Yarralumla Residents Association Inc.
ABN 23 511 882 495

**Yarralumla Residents Association submission in response to
Canberra Brickworks and Environs Planning and Development Strategy 2015**

The Canberra Brickworks and Environs
Planning and Development Strategy
February 2015 Land Development Agency

Fig. 8 Section of proposed cut and fill across site From Denman Street to New Cotter Road Brickworks Road junction

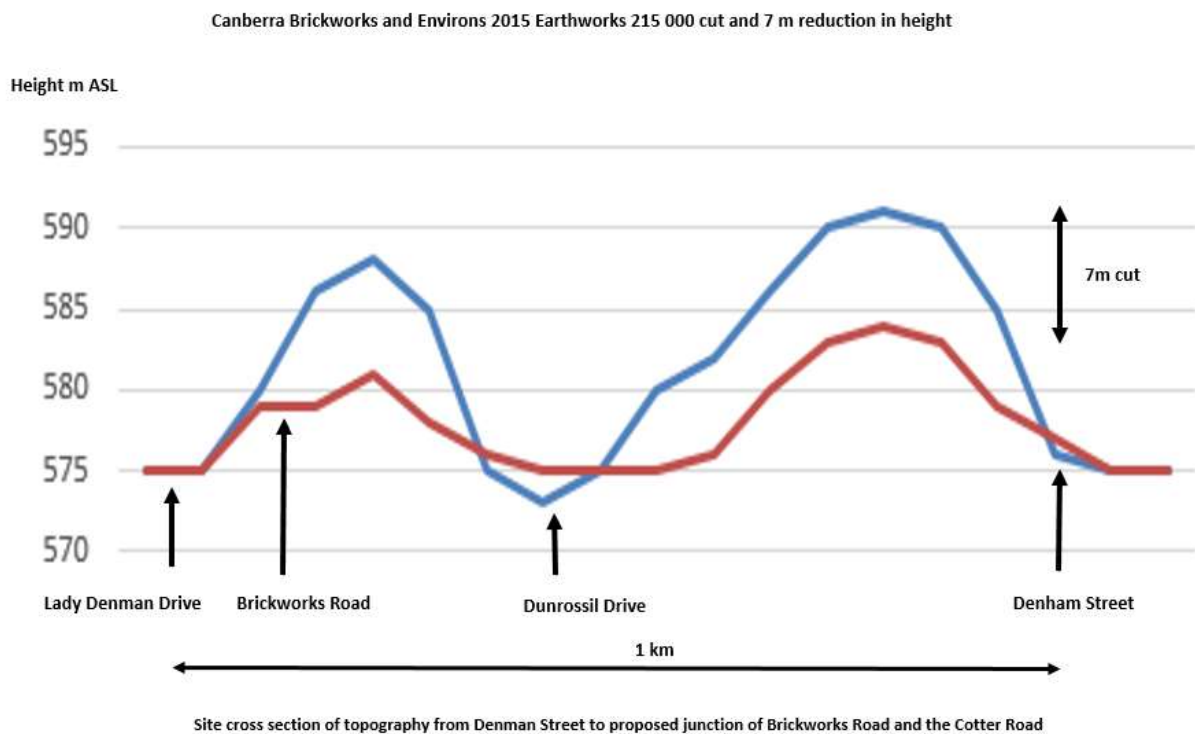
The 2015 development however is in conflict with both the National Capital Plan and the above Tree Assessment Report. The development will eliminate the ridges that are 590m high and covered with 14m high mature trees. In its place will be an essentially flat high density development. The earthworks of 215 000 cubic metres of cut to reduce the height by 7m and the 205 000 cubic metres of fill will eliminate gullies and undulations giving low slope gradient across the whole 49ha site.

This site levelling will enable the construction of 1850 dwellings of which 55% will be apartment blocks of 4 to 8 storeys as the reduction in the height of the ground will avoid the need to comply with the requirement that in Canberra Central no building or structure which protrudes substantially above the tree canopy shall exceed a height of RL617m. However it still does not meet the principle that buildings in Canberra Central should be of a height generally not greater than the height of the natural tree canopy [typically 3 to 4 storeys].

The site levelling will also eliminate the entire habitat of the critically endangered Golden Sun Moth (Fig 23 and 24) and the 1.5 hectare of protected natural temperate grassland. These communities have been assessed as viable with long term survival expected (Rowell 2012 Umwelt 2015). Thus developing housing on this entire habitat does not meet the policies and standards applying to the environment in the National Capital Plan which requires such communities to be protected.

Fig. 10 Dunrossil Drive looking south at the segment that will be eliminated (March 2015)

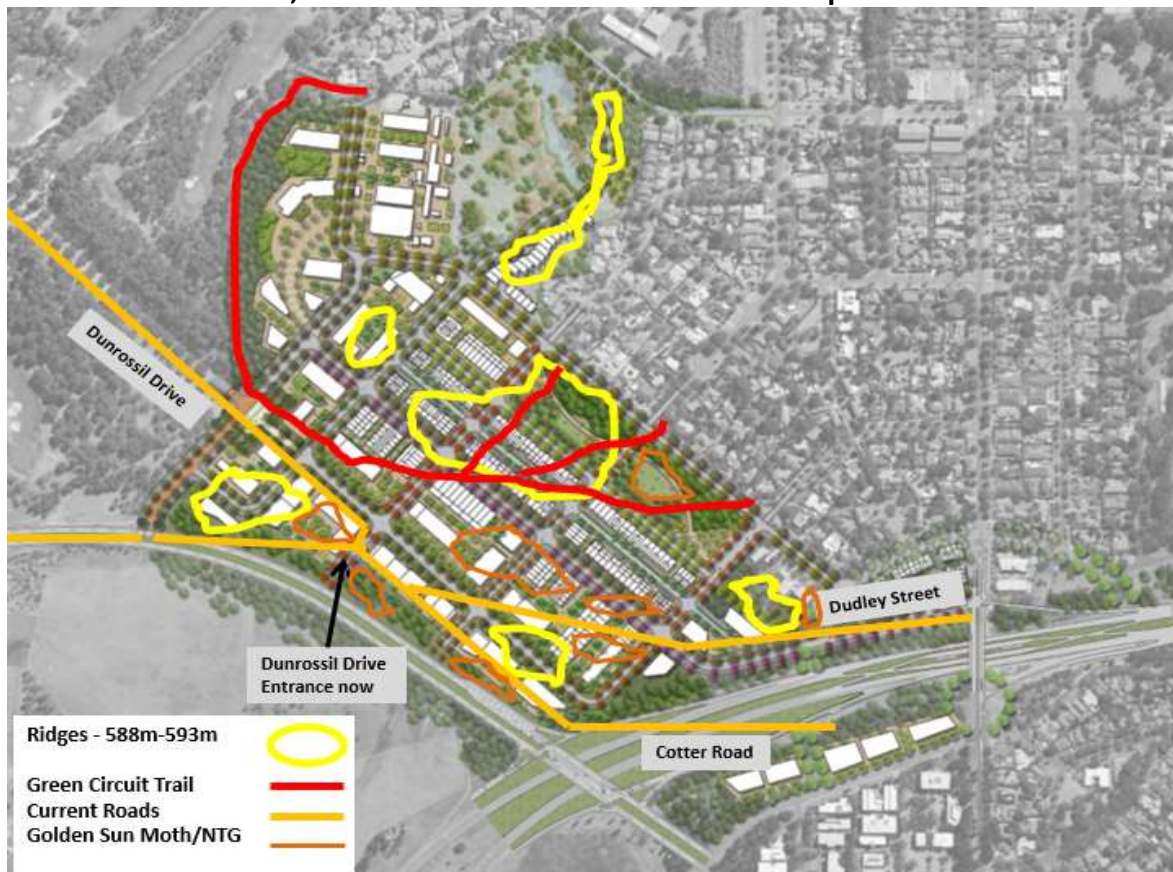
The current access to Dunrossil Drive directly off the Cotter road will be removed and entry will be via a new road, the Brickworks Road which will be the sole access and egress point to the Cotter Road arterial for the 1885 dwelling housing development. Entry to Dunrossil drive will be by a right hand turn off Brickworks Road and Dunrossil Drive itself will be foreshortened by over 20% with the loss of at least 30 of the 1918 plantings of Ulmus

carpinifolia through the earthworks and construction of roads services and apartment blocks. This does not meet the requirement for heritage protection for natural or cultural heritage included on the register of the National Estate. In addition Brickworks Road will be the main service road through the development for the Canberra Brickworks and shops and this may pose security issues for visiting dignitaries that periodically precludes access for residents to some 1500 dwellings.

Fig.17 Development Cut and Fill (SMEC 2015) - red is cut of 7 metres, purple fill is 9.4 metres

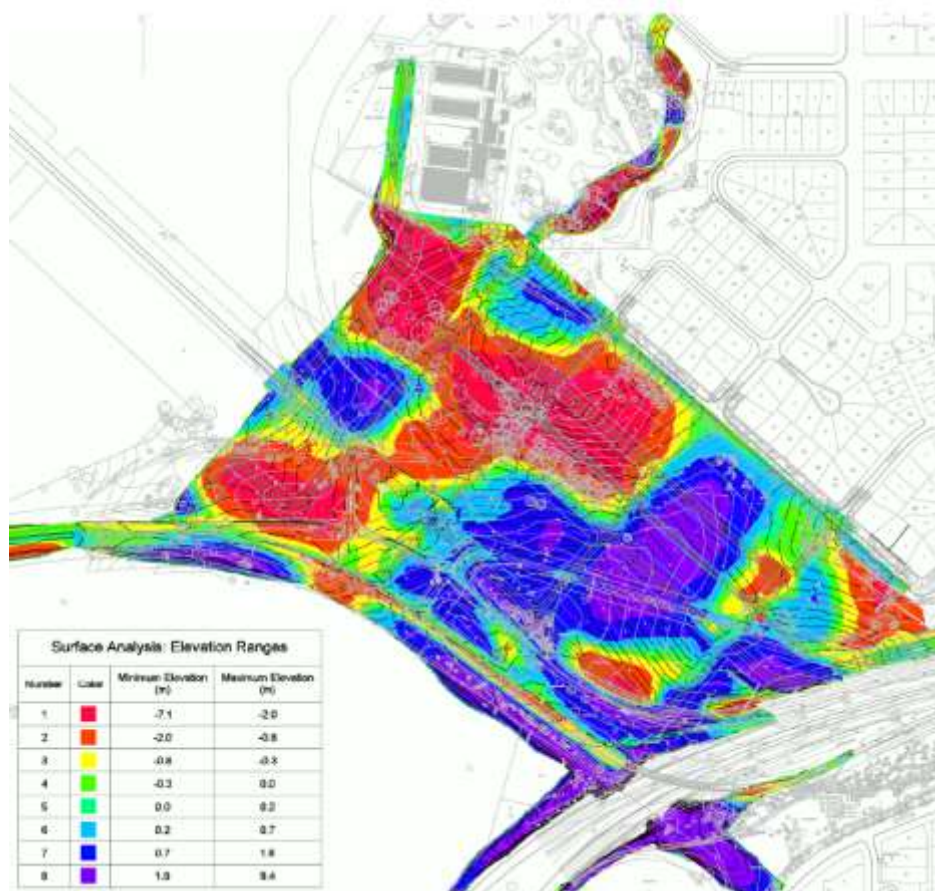
The SMEC report on the 2015 development shows (fig ES.7 (below) that extensive earthworks are required with 215000 cubic metres of cut. This eliminates all topographical relief of the site with some 205000 cubic metres cut being used to fill low-lying areas. The site currently ranges from 575m ASL high to over 590m ASL high. This fall of more than 15 meters will be reduced to about 4 metres across the whole site.

This cut is exceedingly large and reduces the ground height across the site by a massive 7 metres. The main shale ridge line that extends from Denman Street in the north east, south

and west to Dunrossil drive and then west to the Cotter Road is totally removed. This natural ridge also extends from Denman Street north to the Brickworks and this too is removed.

Fig. 18 Cross Section of impact of development cut and fills on landforms

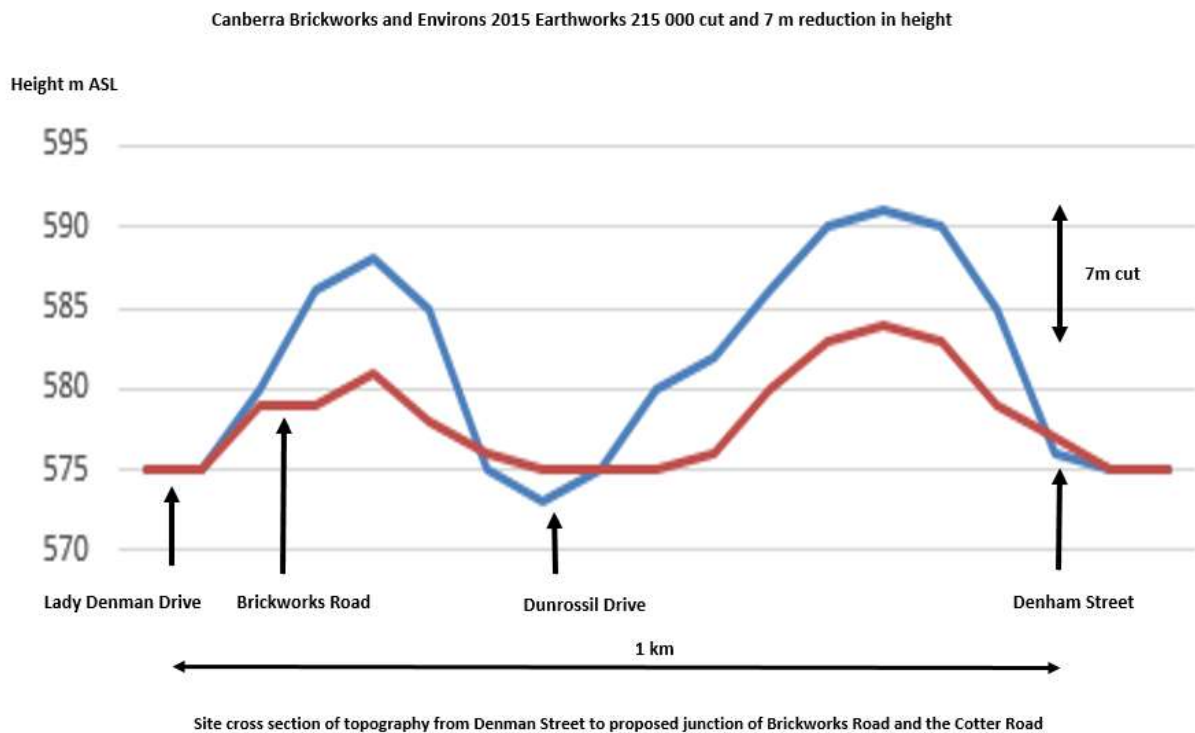
The current natural shale ridge lines are at 590m ASL and have a dense cover of mature trees 10 to 14 metres high. This provides a visual green buffer ridge 14m higher and is a landscape scale asset at the entrance to Dunrossil Drive leading to the Governor General’s residence. This substantial ridge is reduced down to the level of Denman Street of 580m ASL.

Fig. 26 Condition of Canberra Brickworks buildings 2010

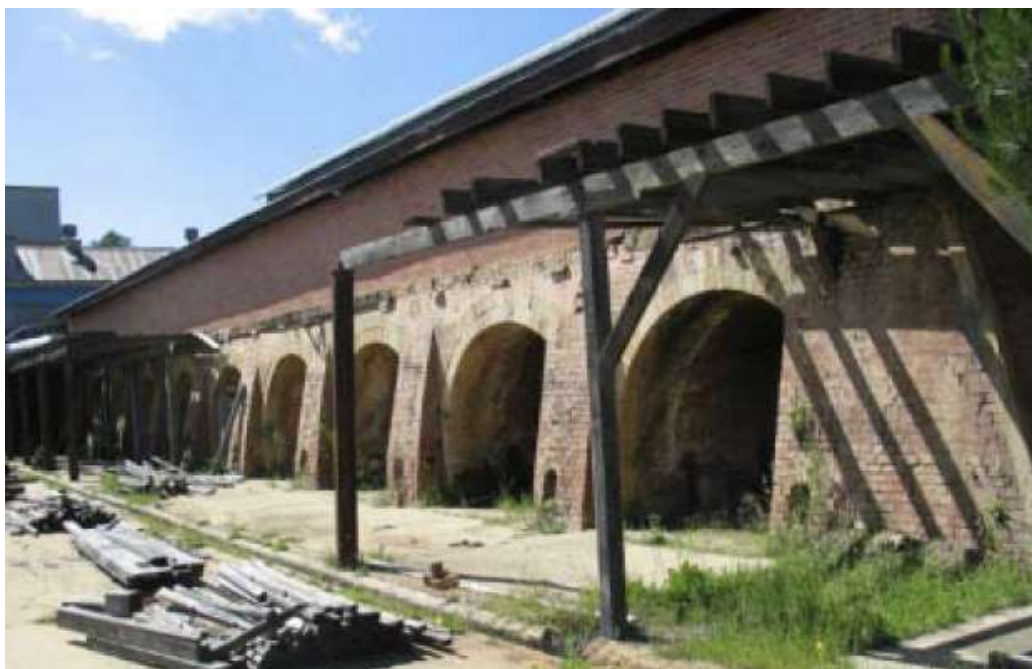
The buildings on this site are generally in fair to poor condition and some are in a relatively advanced state of decay. Therefore there needs to be a tandem process of establishing a long term future use (which will evolve over time) with the need to make the site safe and halt the acceleration of decay.”

For example the 2010 Conservation Management Plan states: 'Kiln 1, the Staffordshire Kiln (Building 4), has significant structural issues. Many of the kiln chambers are distorted although they appear to be stable at present. The arched entrance brickwork is failing in many of the chambers. The arched openings appear to have inadequate footings, probably due to movement in the flue tunnels beneath the outer walls of the kiln. Rebuilding of the worst of these is recommended in the near future.'

Thus the Lovell Chen 2015 Conservation Strategy is one possible future depending on available funding at the time. The ACT Government has currently not appropriated (set aside) any monies for this purpose. Moreover the LDA in its 2014 FAQ stated that 'Commercial feasibility studies undertaken by MacroPlanDimasi in 2012-13 indicate that independent private sector investment in the adaptive reuse of the Brickworks heritage buildings... is unlikely to be viable'. This report has been classified as commercial in confidence by the LDA.
